18 March 2019

**Re: OBJECTION TO DEVELOPMENT PROPOSAL (DA2019/0145) at No. 39  
Adelaide Street, Clontarf**

Figure 1.5 Proposed Southern Elevation, Source: Architectural Plans prepared by Red Blue Architecture, Drawing No. DA0204

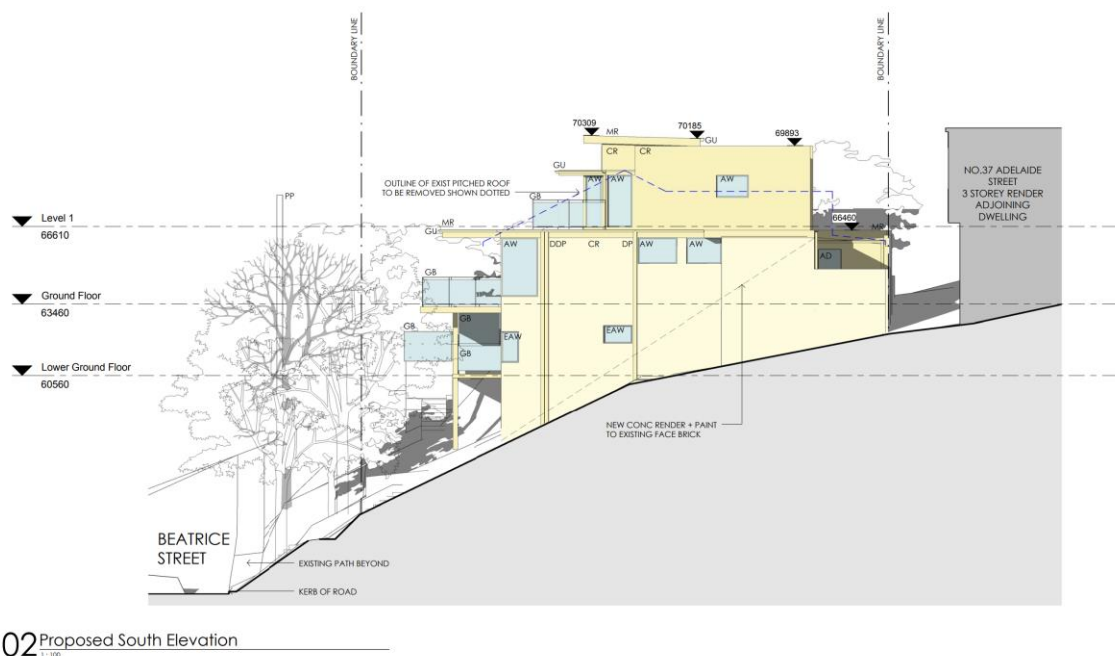
The southern elevation shown above demonstrates non-compliance with Clause 4.1.8 of the Manly DCP. We acknowledge that the site has substantial topographical constraints; however, the slope of the site has not been adequately considered when designing the subject dwelling. The planning controls for this precinct have been determined to ensure new buildings step their proposal with the site which would therefore create compliances with building height, setbacks and substantially reduce the overall impact of the excessive FSR noncompliance.

As the proposed development has not considered the above-mentioned clause, the resultant building is of a bulk and scale that will have substantial adverse impacts on neighbouring properties, in particular our client's property. If the proposed dwelling generally complied with the provisions of this clause, and Clause 4.1.2.2 of the Manly DCP2013, the development would extensively reduce its bulk and scale and result in a building that minimises its adverse impact on the immediate locality.
